Mount St. Helens Project Cowlitz River Levee Systems 2009 Level of Flood Protection Update Summary

Cowlitz River at Longview/Kelso, Washington

February 4, 2010

The HEC staff has completed the review of the *Mount St. Helens Project Cowlitz River Levee Systems - 2009 Level of Flood Protection Update* report. Notice is hereby given that an independent technical review, that is appropriate to the level of risk and complexity inherent in the project, has been conducted as defined in the Quality Control Plan. During the independent technical review, compliance with established policy principles and procedures, utilizing justified and valid assumptions, was verified. This included review of: assumptions; methods, procedures, and material used in analyses; the appropriateness of data used and level obtained; and reasonableness of the result, including whether the product meets the customer's needs consistent with law and existing Corps policy. The independent technical review of the performance analyses was accomplished by Beth Faber, PhD, PE, Woodrow Fields and Michael Deering, PE, D.WRE. All comments resulting from ITR have been resolved.

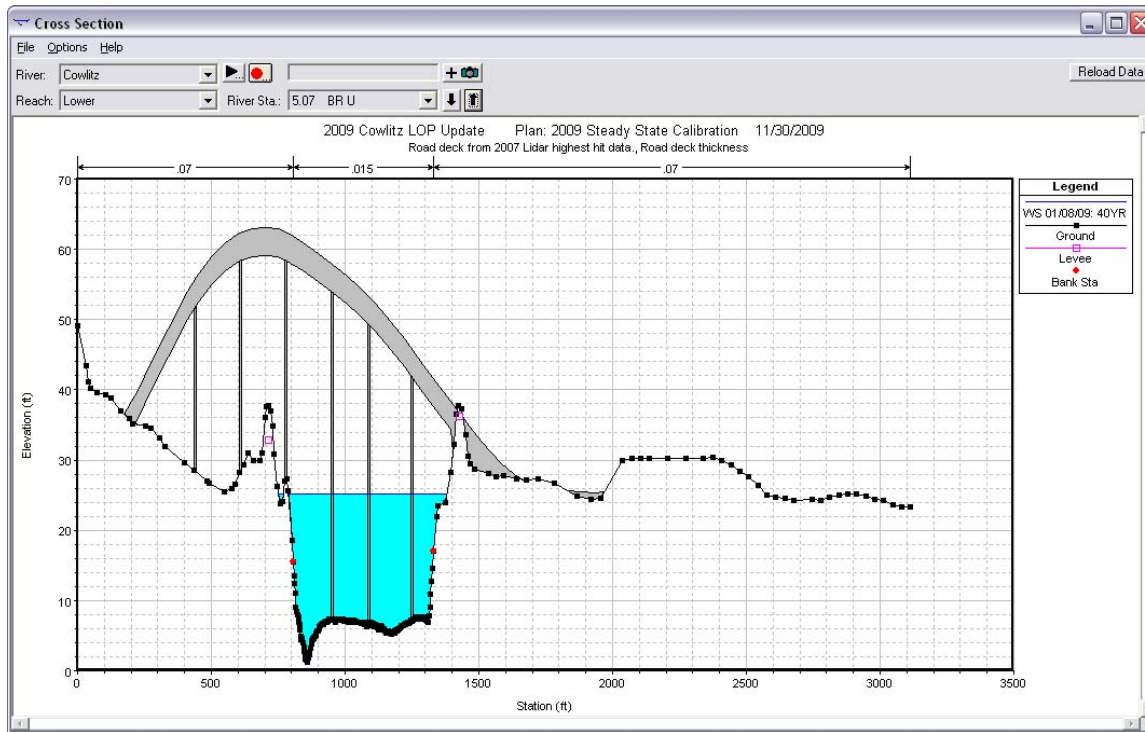
Using only one event for calibration does not ensure model accuracy for the entire range. If the value of 0.015 is in fact correct for the calibration event, Figure 4-1 would suggest varying roughness values over the range of discharges. Consideration should be given to using flow roughness factors within HEC-RAS to account for the changing roughness. Consider calibration to gage data over the entire range of available discharges using flow roughness factors. If calibration to gage data has been evaluated, results should be presented in the report.

NWP Response: Please see response to Model Calibration/Verification comment 1.

Figure F. 2: Lower and upper regime bedform classification (Athaullah, 1968)

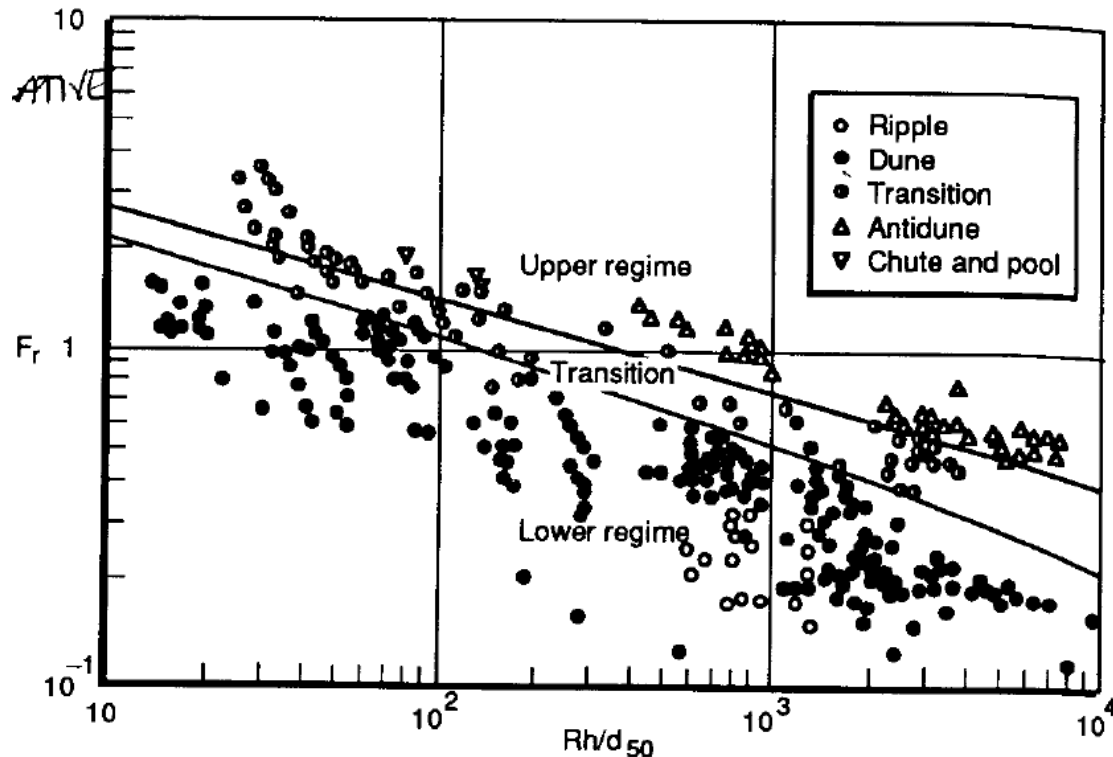
It is agreed that the roughness during the relatively high flow event could be low, but it is not clear that Figure C.5, based on a river in Bangladesh, provides adequate justification for using a roughness value that approaches that of concrete. The conclusion in section C.5.4, page 131, that “a review of the hydraulics for the lower 8 miles of the river using Van Rijn’s method for predicting bed regime provides evidence of regime changes around the calibration event” should contain additional support. From Figure 4-3, page 19, it appears that the regime change occurs at a much higher discharge than that of the calibration event. Is this interpretation correct?

From theoretical formulations of the velocity profile, an estimate of the Manning's roughness was made based on the d_{50} present in the channel. The estimates of Manning's roughness show that as the bedform changes from dunes (lower regime) to upper regime (washed out dunes) the roughness value drops precipitously. This result corresponds to empirical data shown in the plot of Manning's n versus discharge in Figure 4-1 of the LOP report. Below RM 10, for the flood with low AEP where washed out dunes are present, computed roughness values were generally in the range of 0.014 to 0.020. Published tables from Julien (1998), which relate Manning's coefficient to bedform, supports the contention that near the upper regime conditions where washed out dunes are present; the roughness coefficient can drop to between 0.014 to 0.020.
